ADDENDUM NO. 2

NOTICE TO BIDDERS OF PROJECT NO. 20223 RAY WILLIAMSON POOL IMPROVEMENTS – PHASE 1

Bainbridge Island Metro Park & Rec District: Ray Williamson Pool Improvements

ASK 2 - REFERENCE DETAIL 3/AD-3.2
 RAY WILLIAMSON POOL RENOVATION PHASE 1
 8521 MADISON AVENUE N
 BAINBRIDGE ISLAND, WA 98110

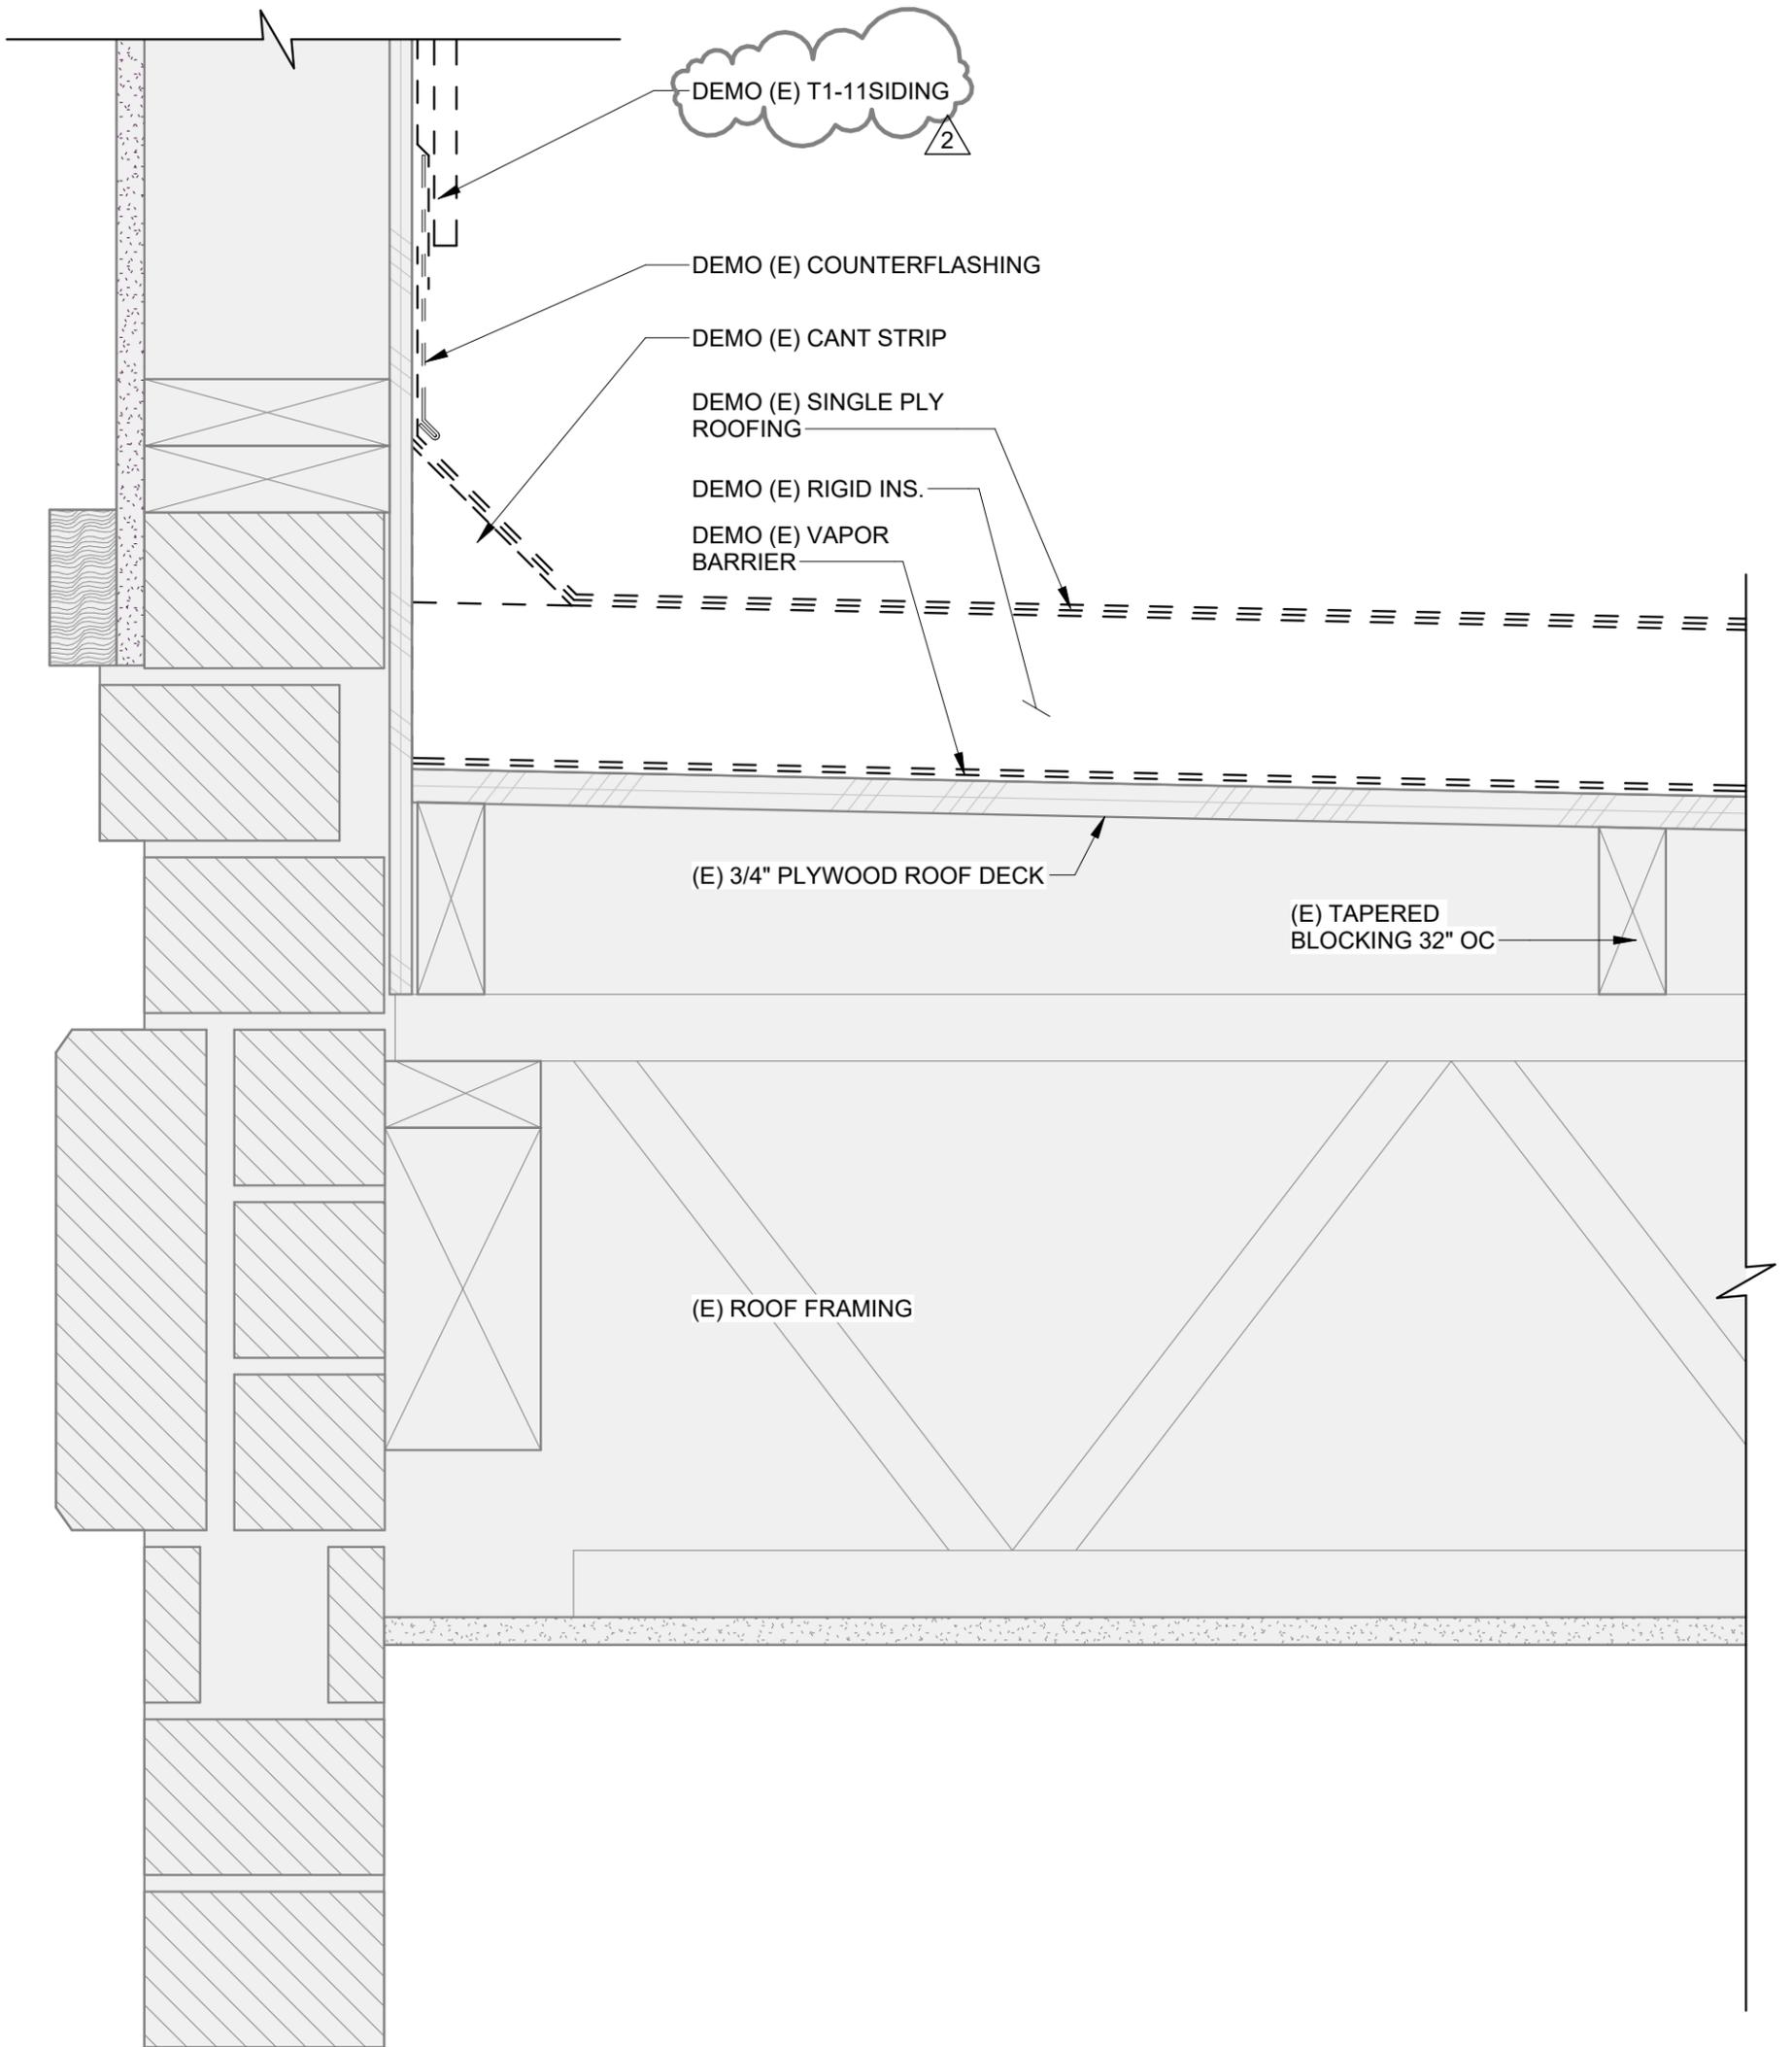
10. Sheet AD-3.2 Roof Demo Details
DELETE detail 3/AD-3.2 (E) Roof to Wall at Siding - Demo and **REPLACE** with ASK-2 with note DEMO (E) T1-11 SIDING, attached in Addendum No. 2.

ASK 3 - REFERENCE DETAIL 3/A-4.3

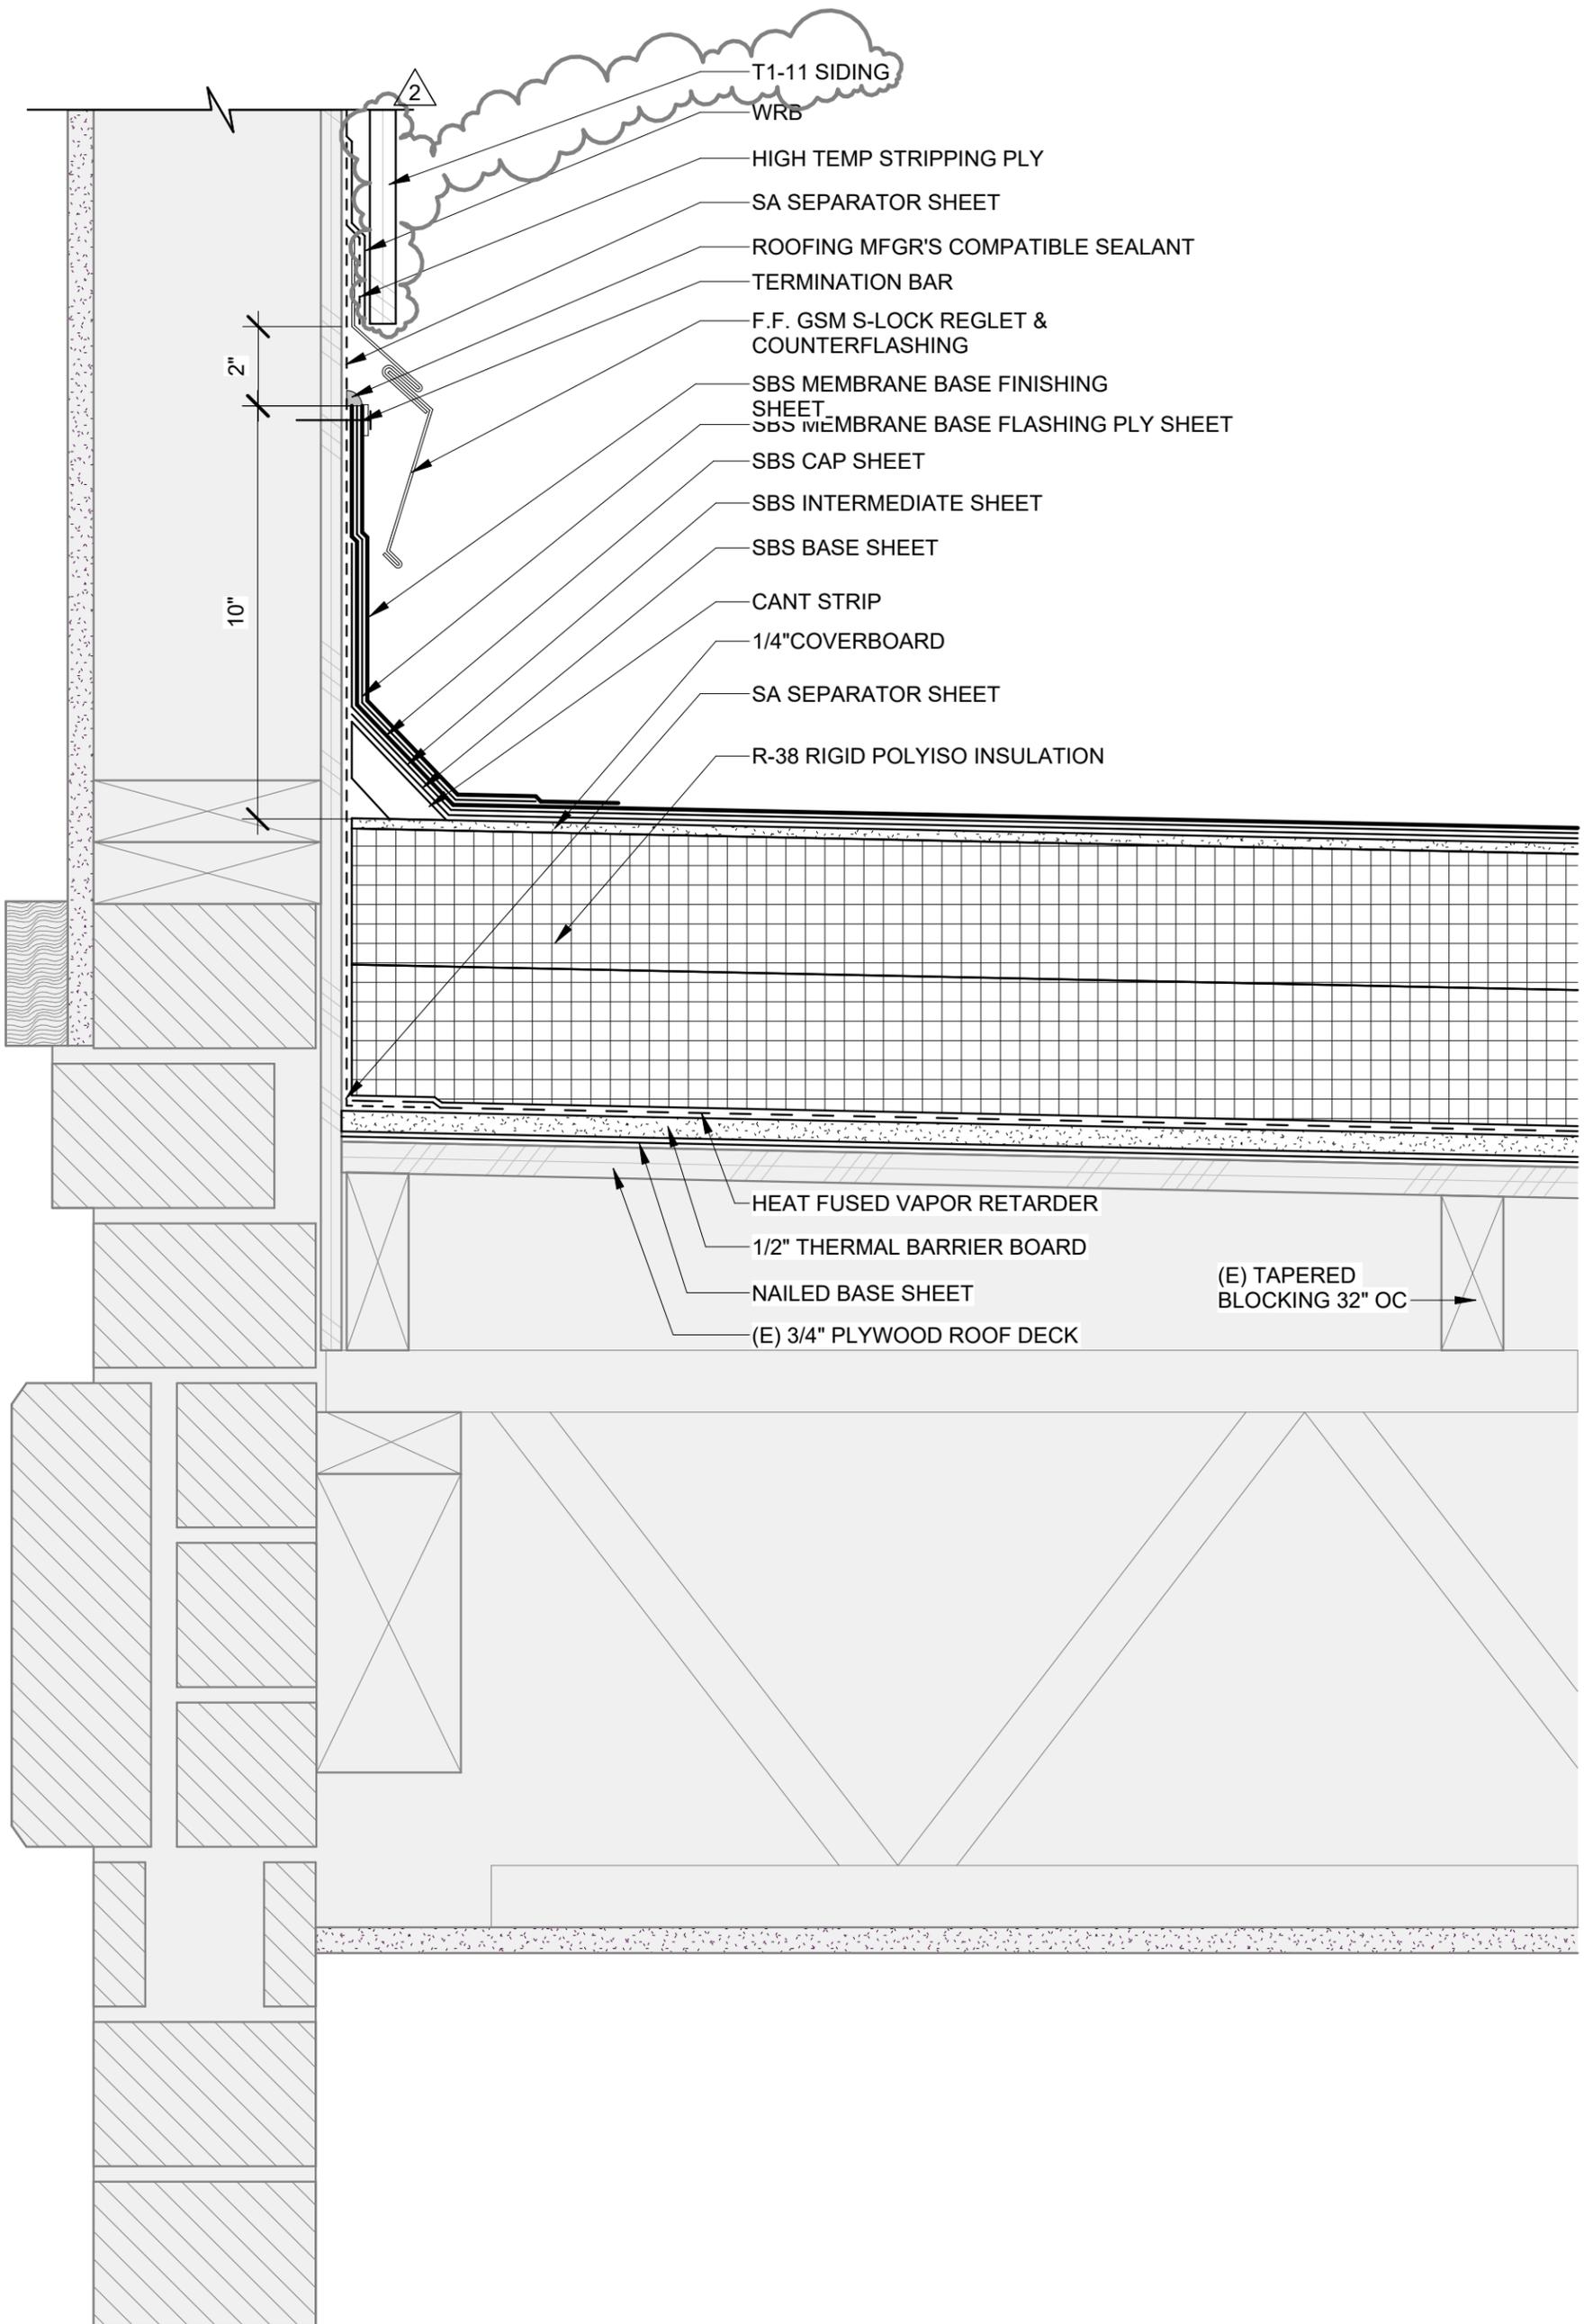
11. Sheet AD-4.3 Roof Details
DELETE detail 3/A-4.3 Roof to Wall at Siding and **REPLACE** with ASK-3 with note DEMO (E) T1-11 SIDING, attached in Addendum No. 2.

ASK 4 - REF DETAIL 7/A4.6
 RAY WILLIAMSON POOL
 RENOVATION PHASE 1
 8521 MADISON AVENUE N
 BAINBRIDGE ISLAND, WA 98110

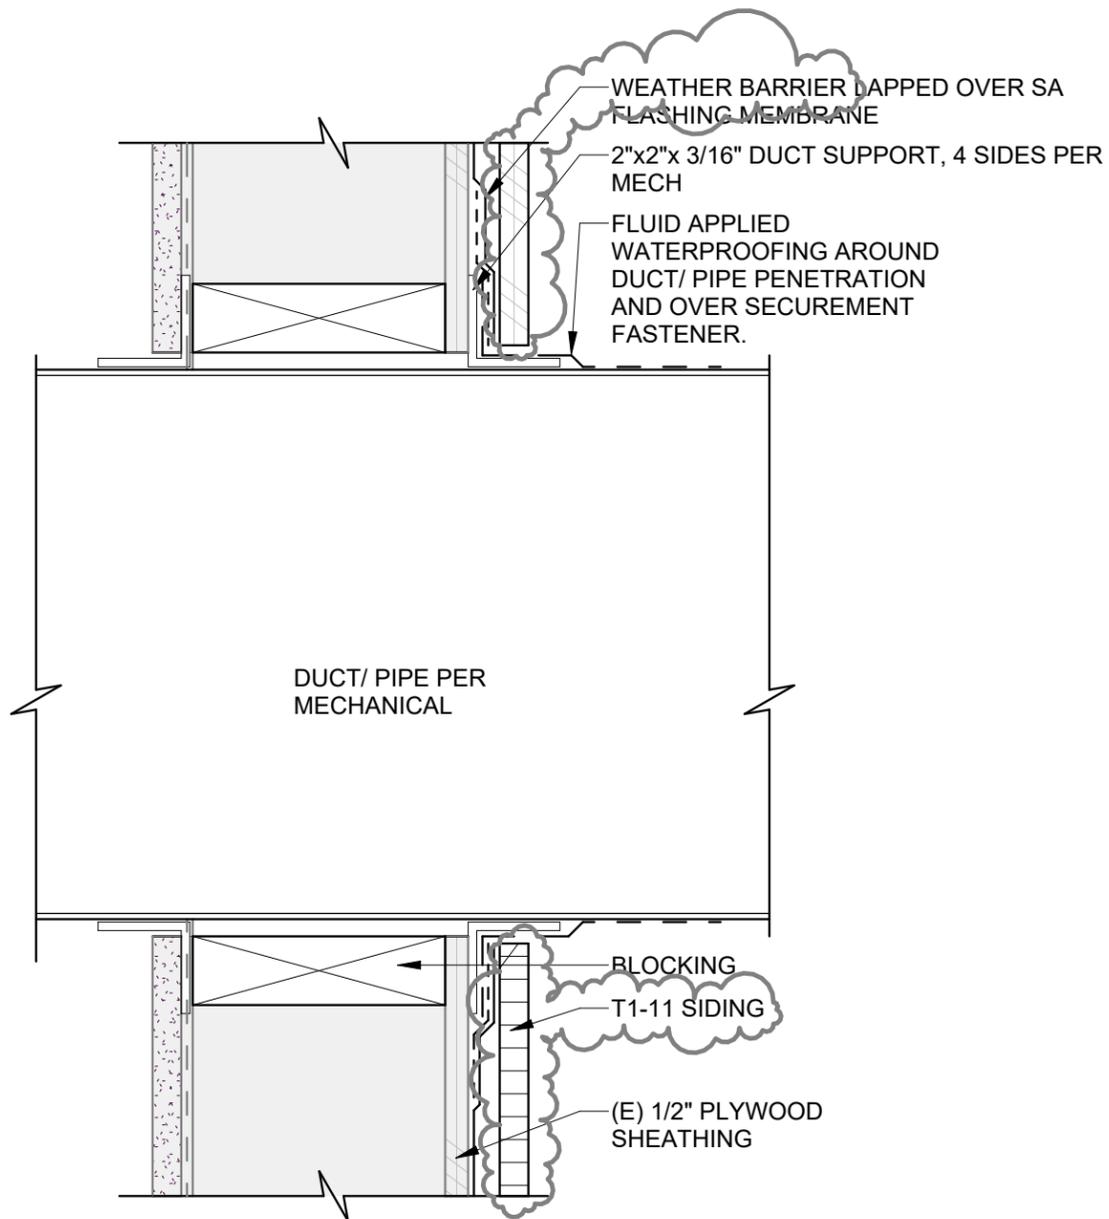
12. Sheet AD-4.6 Roof Details
DELETE detail 7/A-4.6 Mechanical Wall Penetration and **REPLACE** with ASK-4 with note T1-11 SIDING and FLASHING MEMBRANE, attached in Addendum No. 2.

CLARIFICATION OF BID QUANTITIES FOR CMU/BRICK RESTORATION RAY WILLIAMSON POOL RENOVATION PHASE 1 8521 MADISON AVENUE N BAINBRIDGE ISLAND, WA 98110	PIC MSL	BID SET PHASE 1 5/8/2024 SSK 1.1
	PM MSL	
	DRW	2208

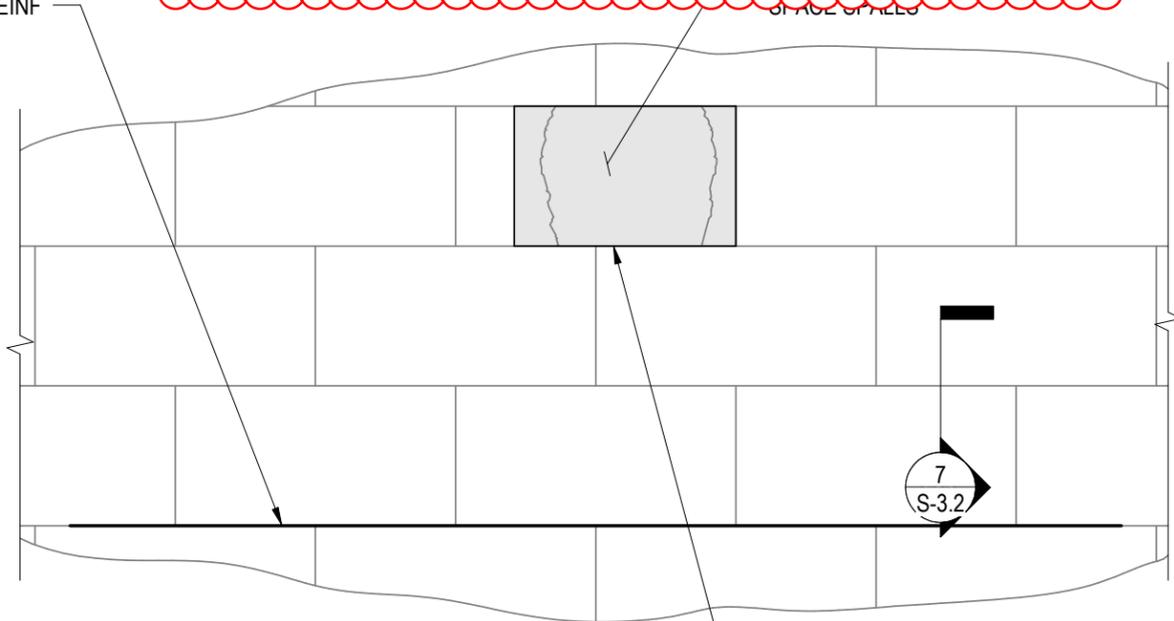
1. Sheet S-3.2 Details **DELETE detail** 5/S-3.2 Exterior 2"x8" Hollow Core Brick/Masonry Repair and **REPLACE** with SSK-1.1, attached in Addendum No. 2.
ADD note ALLOW FOR REPAIR OF 120 BRICK FACES TOTAL IN PROJECT, INCLUSIVE OF EXTERIOR & INTERIOR PORTIONS OF BUILDING (CONFIRM LOCATIONS WITH PROJ. REP.) PROVIDE CLEANING OF LAITANCE AND STAINS AT THE ENTIRE EXTERIOR AND EXPOSED SURFACES OF THE INTERIOR OF BRICK.PROTECT EXISTING GAS PIPING, WHERE OCCURS, AS SHOWN ON MEP DRAWINGS.
2. Sheet S-3.2 Details **DELETE detail** 7/S-3.2 K-Web Mortar Joint Repair Detail and **REPLACE** with SSK-1.2, attached in Addendum No. 2.
ADD note DETAIL 7 QUANTITIES: ALLOW FOR RE-POINTING OF 100% OF MORTAR JOINTS AT EXTERIOR & INTERIOR OF BLDG. ALLOW FOR REPAIR OF K-WEB AT EXTERIOR OF BUILDING AS FOLLOWS:
WEST ELEVATION: 100%
SOUTH ELEVATION: 50% (CONFIRM LOCATIONS WITH PROJ. REP.)

EAST ELEVATION: 50% (CONFIRM LOCATIONS WITH PROJ. REP.)

Q4: The areas of repairs for the existing masonry brick are not quantified and several areas are likely unforeseen. How would you like for us to price? We would recommend that the bid form provide a unit price.

A4: ***The quantities for existing masonry brick repair are noted in SSKs 1.1 and 1.2.***

DETAILS 2 & 6 QUANTITIES: ALLOW FOR REPAIR OF 120 BRICK FACES TOTAL IN PROJECT, INCLUSIVE OF EXTERIOR & INTERIOR PORTIONS OF BUILDING (CONFIRM LOCATIONS WITH PROJ. REP.) PROVIDE CLEANING OF LAITANCE AND STAINS AT THE ENTIRE EXTERIOR AND EXPOSED SURFACES OF THE INTERIOR OF BRICK.
